RESPONSE IN RED

Dealing with the issues in the order of the documents on PA.

Section showing fascia not shown on the elevations.

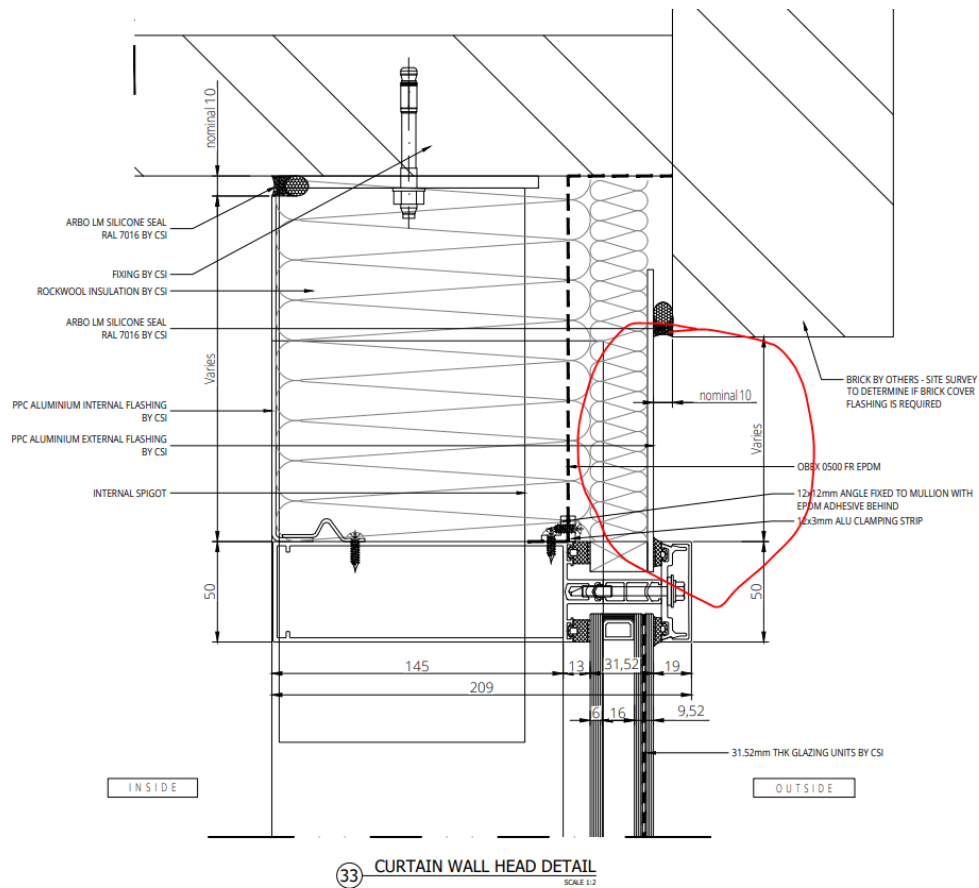
The proposed curtain walling relates to the new doorway in the gable end. The frame shown seems excessive in size and amounts to a total of 209mm of frames. See the detailed section below. Elevations submitted with the application show a much slimmer frame - in addition the detailed drawing submitted to discharge the condition show a metal fascia above the door which is not shown on the elevation below. The detail should match the elevation and be the full extent of the opening.

This screen is still being developed and fascia will not form part of proposal.

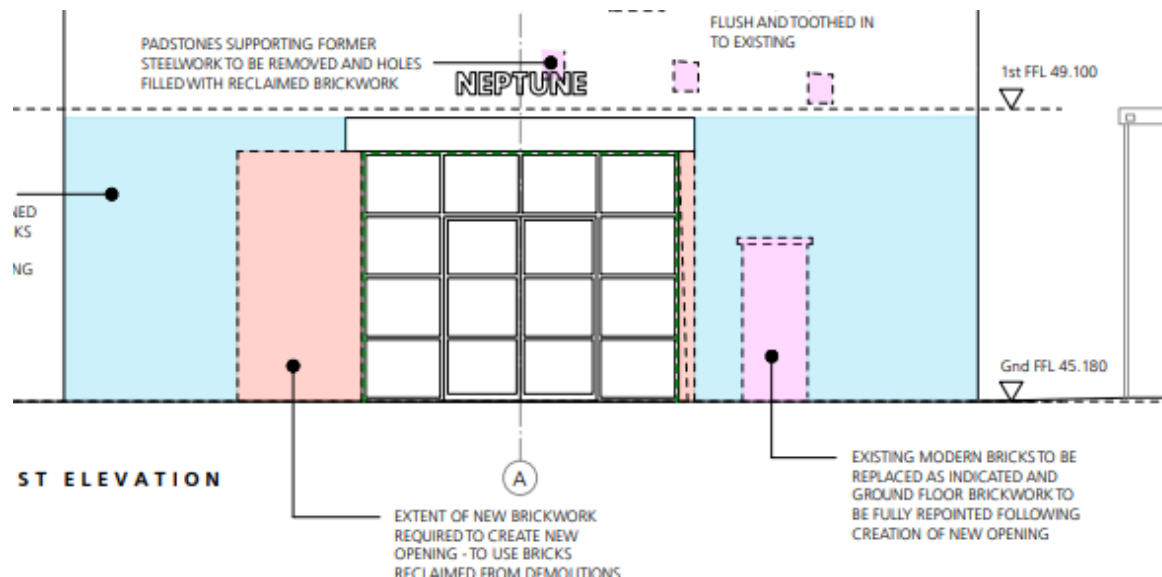
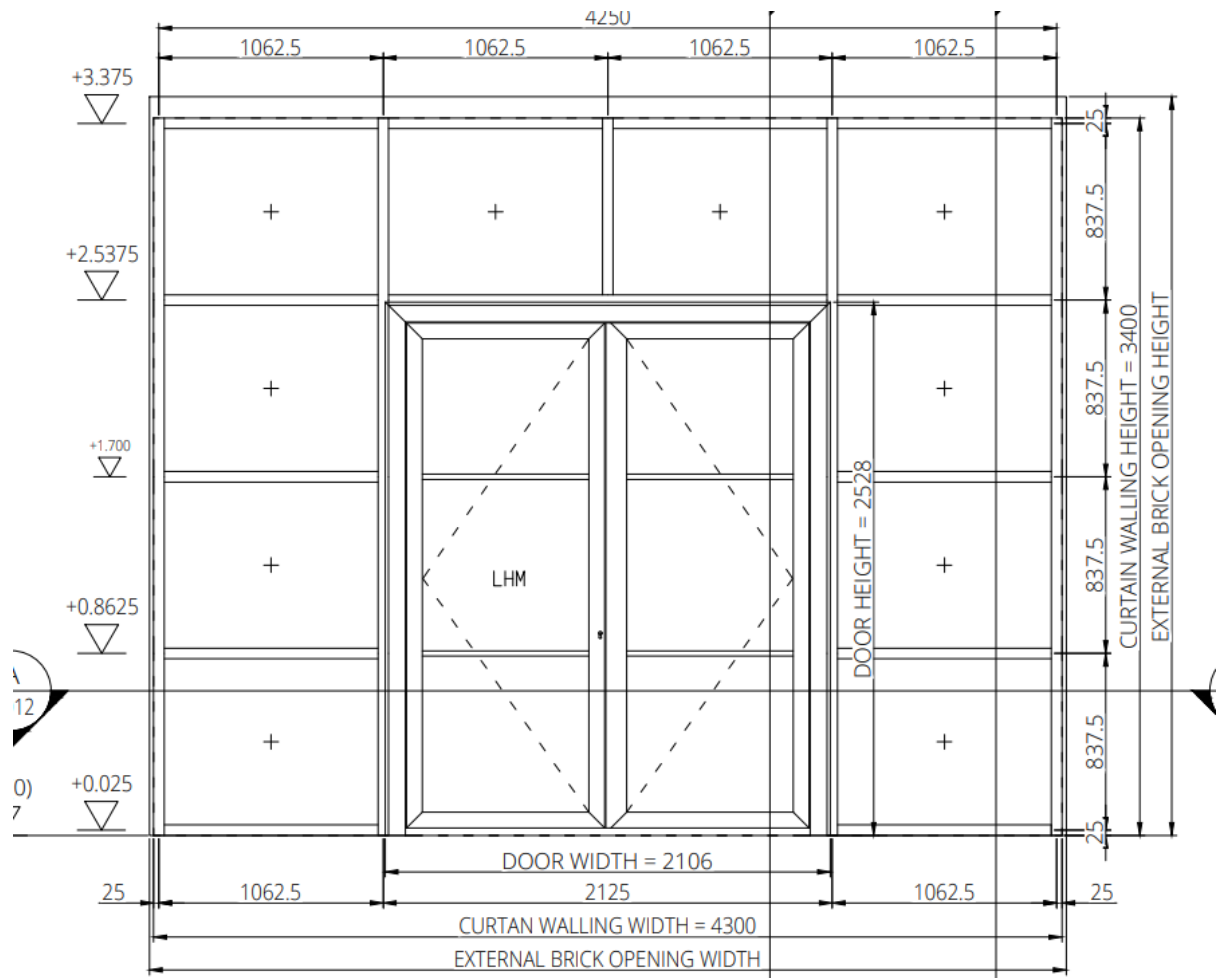
Design below showing heavy framing to doorset. Not shown as heavy on elevation drawing below this.

This is as shown on approved drawing 353 CD 3004, which is the larger scale version (1:25) of the screen rather than the 1:100 GA elevation. Intermediate door frame is slightly larger than originally drawn but we do show three separate frames. Frame sizes are governed by size and weight of doors and wind loading and security requirements.

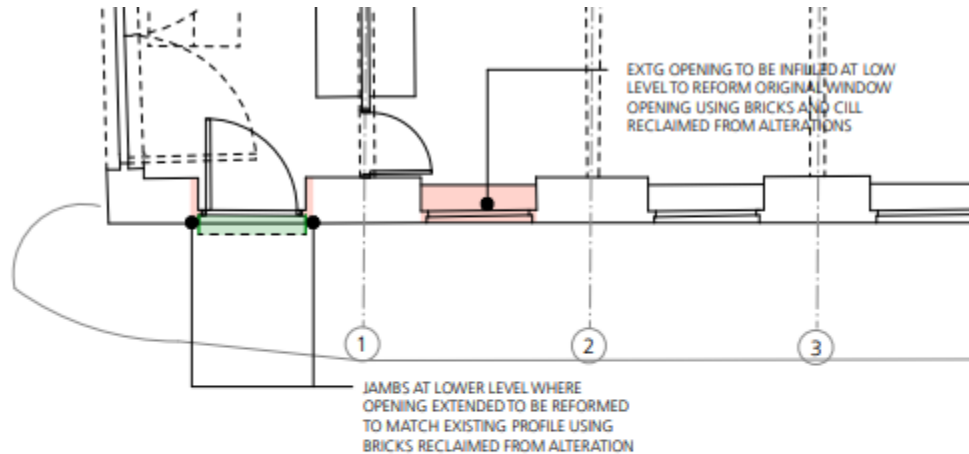
There is some discrepancy on the plans. The ground floor plan shows a PCC sleeve to the new window which is not on the elevations. The note on the plans should be removed as the opening should be simply the brick reveals of the window / door without a sleeve lining.

Approved drawings 353 CD 2101 (Plan) plus CD 2106 & 2107 (elevations) and detail drawing CD 3106 show window sleeves to two openings. We are proceeding on basis of approved drawings.
